**Cobra 39 Plus Technical Bulletin 1290**

# TECHNICAL BULLETIN

**Number** 1290

MODELS AFFECTED : 39 Plus

FIG. 1

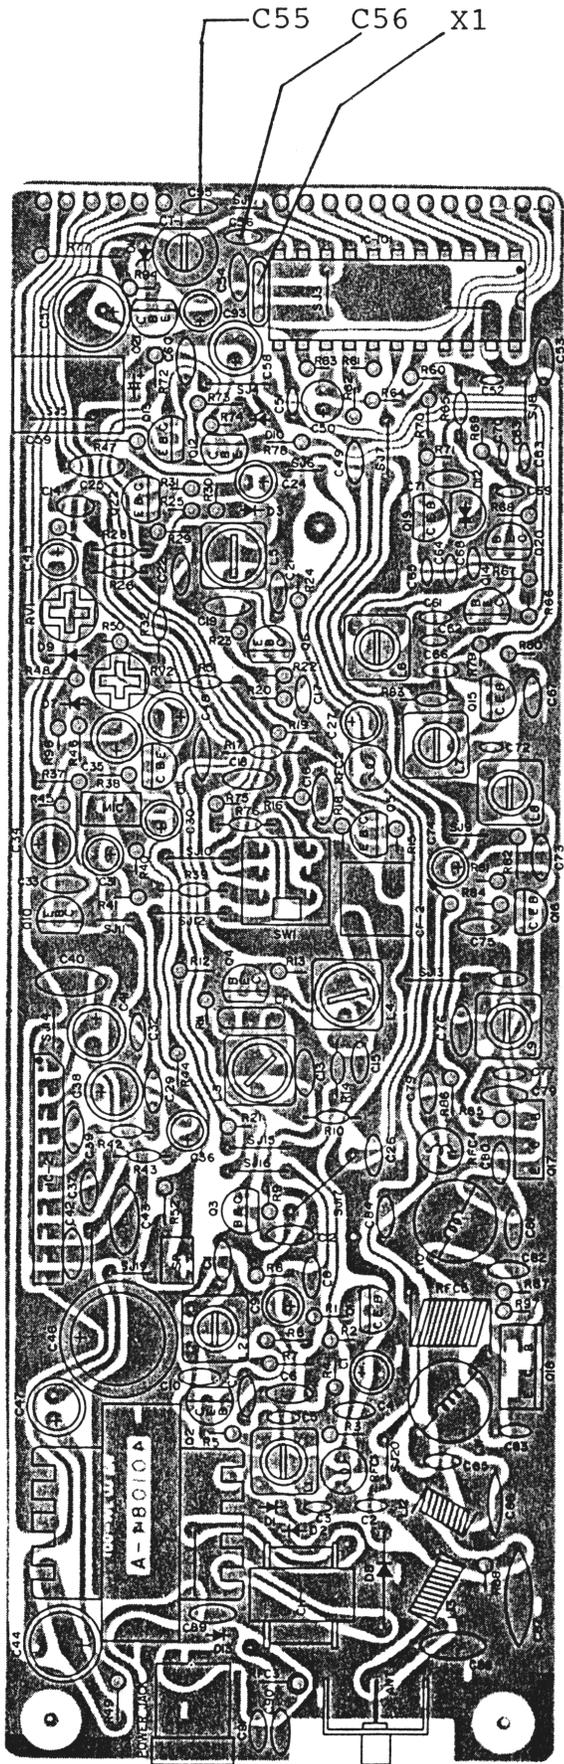
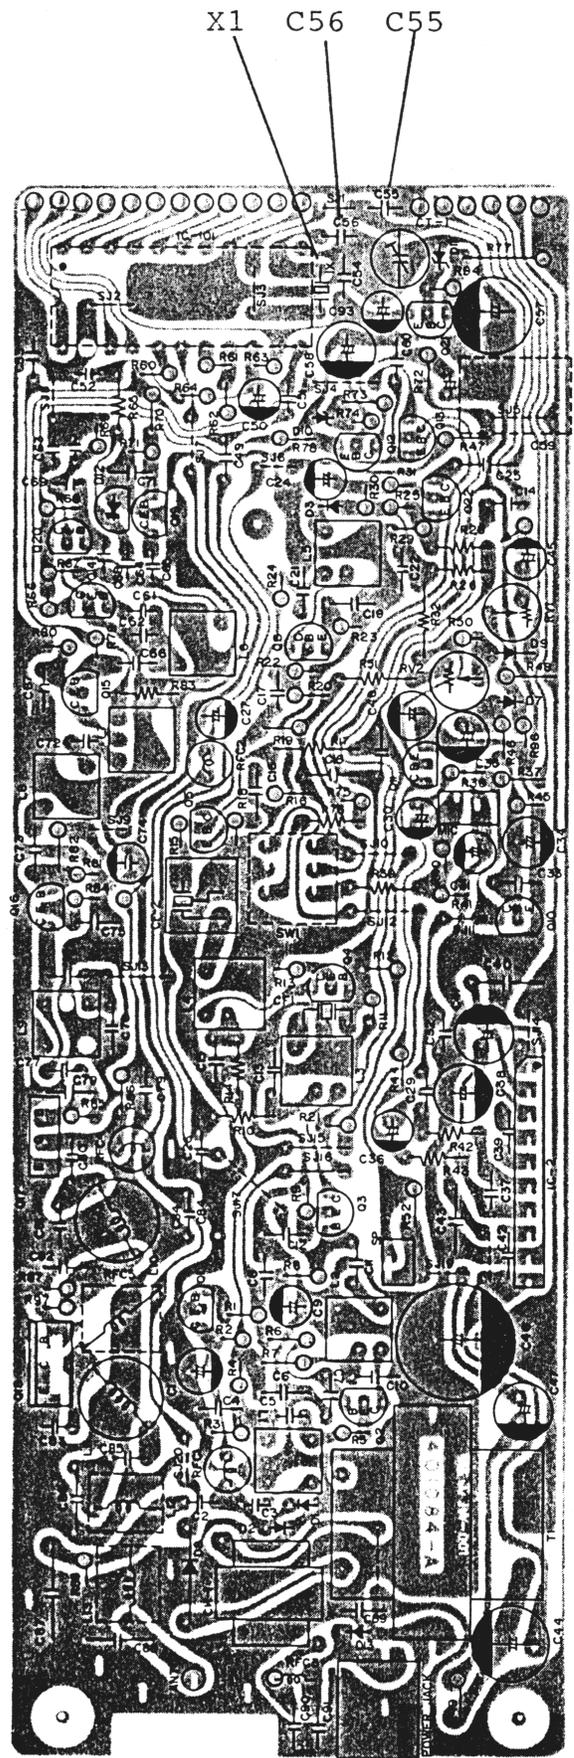
SYMPTOMS : Progressively poor sensitivity or set inoperative (dead) with CH 9 LED lit and no up/down channeling capability.

CAUSE : 10.24MHz (X-1) crystal dead or activity below specification.

ACTION : Replace X-1 (see fig. 1), 10.24MHz crystal with Dynascan P/N 132-036-9-001.

OR Replace X-1, 10.24MHz crystal with Dynascan P/N 135-077-9-001 (Yel Vinyl) and change C55 & C56.  
C55 Cap. Mica 15pF/50V P/N 023-097-9-001  
C56 Cap. Mica 20pF/50V P/N 023-097-9-002

A. Locate C55 and C56 on P.C.B. and remove (see fig. 1).

B. Replace C55 with Mica Capacitor, 15pF/50V (P/N 023-097-9-001).

C. Replace C56 with Mica Capacitor, 20pF/50V (P/N 023-097-9-002)

D. Install new crystal (P/N 135-077-9-001).

4. Before soldering crystal leads, bend crystal so that it can be cemented to IC-1 (marked IC 101 on PCB layout) top, leaving adequate clearance when replacing top cover.
5. Solder crystal leads.
6. Use rubber cement or equivalent contact agent so crystal can not vibrate.
7. Attach a scope probe connected to a counter to Pin 9 of IC1 (marked IC 101 on PCB layout) and adjust CT1 for an indication of 10.24MHz +100Hz.
9. Check synthesizer alignment at TP1 per standard alignment procedure - CH40 (5.0Vdc) and CH1 (1.5Vdc).
10. Reassemble 39 Plus in reverse order of dis-assembly and check overall operation.
